Access Compliance Report

Public Rights-of-Way

Intersection ID: 20587	Main Street: COLONY_RD	Cross Street: FAIRVIEW_RD	Location: SE
ADA ID: BBA27A130CC6	Ramp Type: Para	Initial Pass/Fail: Fail	Overall Compliance: No
Severity Score: 13.75			
Codes/Mitigation Info/Possible Solution		Field Measurements/Component Compliance

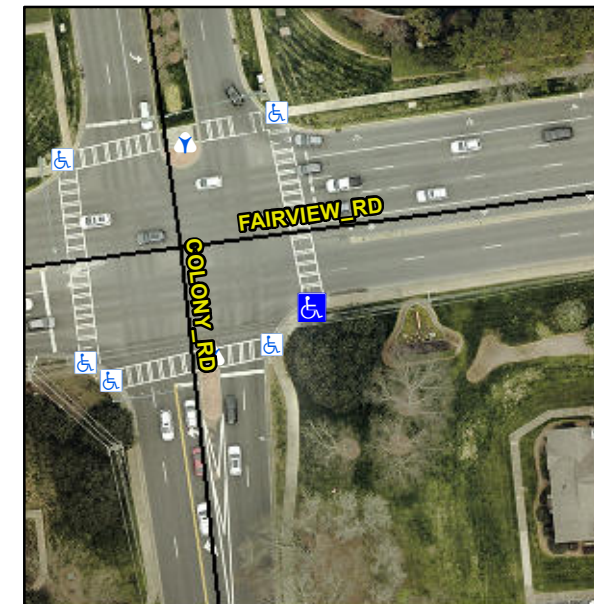
R304.3.2, R304.5.3

Compliance	Description	Data	Compliance	Description	Data
N/A	Ramp Length LT (in)	64.0	N/A	Ramp Length RT (in)	52.0
Yes	Ramp Width LT (in)	60.0	Yes	Ramp Width RT (in)	70.0
No	Ramp Slope LT (%)	8.7	Yes	Ramp Slope RT (%)	7.6
No	Ramp XSlope LT (%)	2.2	Yes	Ramp XSlope RT (%)	1.1
N/A	Landing Length (in)	N/A	N/A	DWS Provided?	N/A
N/A	Landing Width (in)	N/A	N/A	DWS Contrast?	N/A
N/A	Landing Slope (%)	N/A	N/A	DWS Length (in)	N/A
N/A	Landing X Slope (%)	N/A	N/A	DWS Full Width?	N/A
N/A	Landing Curb? (Y/N)	N/A	N/A	DWS Offset (in)	N/A
N/A	Shared Landing?	N/A			
N/A	Gutter Ponding?	N/A	N/A	Gutter Slope (%)	N/A
N/A	Gutter Lip Ht (in)	N/A	N/A	Gutter X Slope (%)	N/A
N/A	Painted X Walk1?	Yes	N/A	Painted X Walk2?	N/A
	X Walk 1 Direction	To N		X Walk 2 Direction	N/A
N/A	X Walk 1 Width (in)	116.0	N/A	X Walk 2 Width (in)	N/A
	X Walk 1 Slope (%)	3.3		X Walk 2 Slope (%)	N/A
	X Walk 1 X Slope (%)	1.4		X Walk 2 X Slope (%)	N/A
N/A	Ramp inside XWalk1?	Yes	N/A	Ramp inside XWalk2?	N/A

Remove & Replace Entire Ramp.
